# UNITED STATES PATENT AND TRADEMARK OFFICE

APPLICATION NO.	FILING DATE	FIRST NAMED INVENTOR	ATTORNEY DOCKET NO.	CONFIRMATION NO.
10/647,666	08/25/2003	James M. Meier	F12.12-0133	2145
27367	7590	04/13/2006	EXAMINER	
WESTMAN CHAMPLIN & KELLY, P.A. SUITE 1400 - INTERNATIONAL CENTRE 900 SECOND AVENUE SOUTH MINNEAPOLIS, MN 55402-3319				EVANISKO, LESLIE J
		ART UNIT		PAPER NUMBER
		2854

<b>Office Action Summary</b>	<b>Application No.</b>	<b>Applicant(s)</b>	
	10/647,666	MEIER ET AL.	
	<b>Examiner</b>	<b>Art Unit</b>	
	Leslie J. Evanisko	2854

## **DETAILED ACTION**

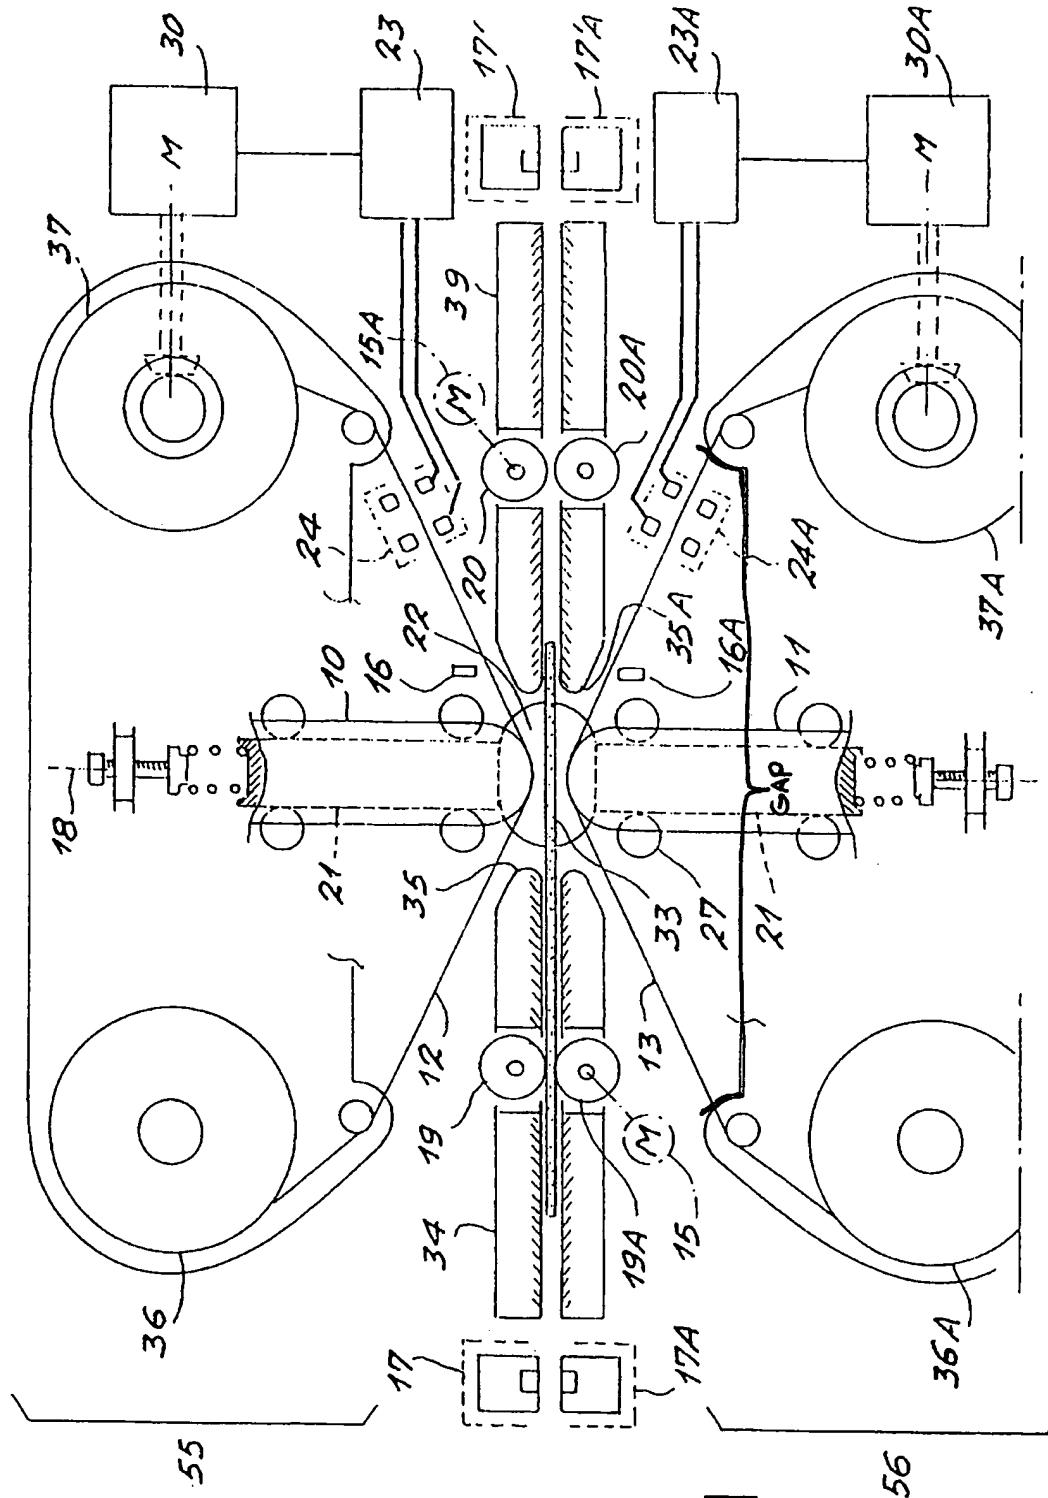
print path (the path defined by 34, 34A, and 39); a printhead 11 below the print path and configured to print an image on a surface of the card 33; a supply of print ribbon 13 extending between supply spool 36A and take-up spool 37A and across a gap (see marked up copy of Figure 1 attached to this Office Action), wherein the printhead 11 is positioned within the gap beneath the print ribbon 13; a ribbon sensor 24A configured to detect ribbon panels of the print ribbon (see column 3, lines 8-9 and column 4, lines 26-27), the ribbon sensor including a component positioned within the gap (again see the marked up copy of Figure 1); and a card output 39 through which the card is discharged.

With respect to claim 3, note the supply and take-up spools 36A, 37A are positioned adjacent opposite sides of the printhead 11 outside of the gap, as shown in the marked-up copy of Figure 1 of Morgavi.

With respect to claim 4, note the supply and take-up spools 36A, 37A of Morgavi are positioned below the print path, as shown in Figure 1.

With respect to claim 12, note Morgavi shows a second ribbon sensor element in Figure 1.
